Access Compliance Report Public Rights-of-Way (Curb Ramps)

Intersection ID: 11147 Main Street: E 21ST ST **Cross Street: N CALDWELL ST** S Location: **Overall Compliance: No Severity Score:** 0 ADA ID: AE19ADF248F8 Ramp Type: Combination1Diag Initial Pass/Fail: Fail

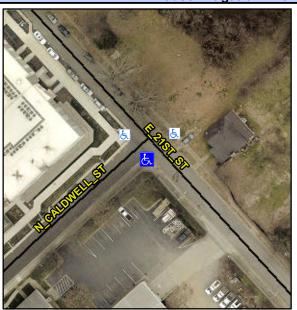
StopSign N CALDWELL ST None E 21ST ST Possible Solutions: Remove & Replace Curb Ramp With Two New Directional Ramps or Equivalent. Surveyor Notes: LT RP < 5% PROW/ADA: R304.5.1, R304.2.2, R304.5.3, R304.3.2
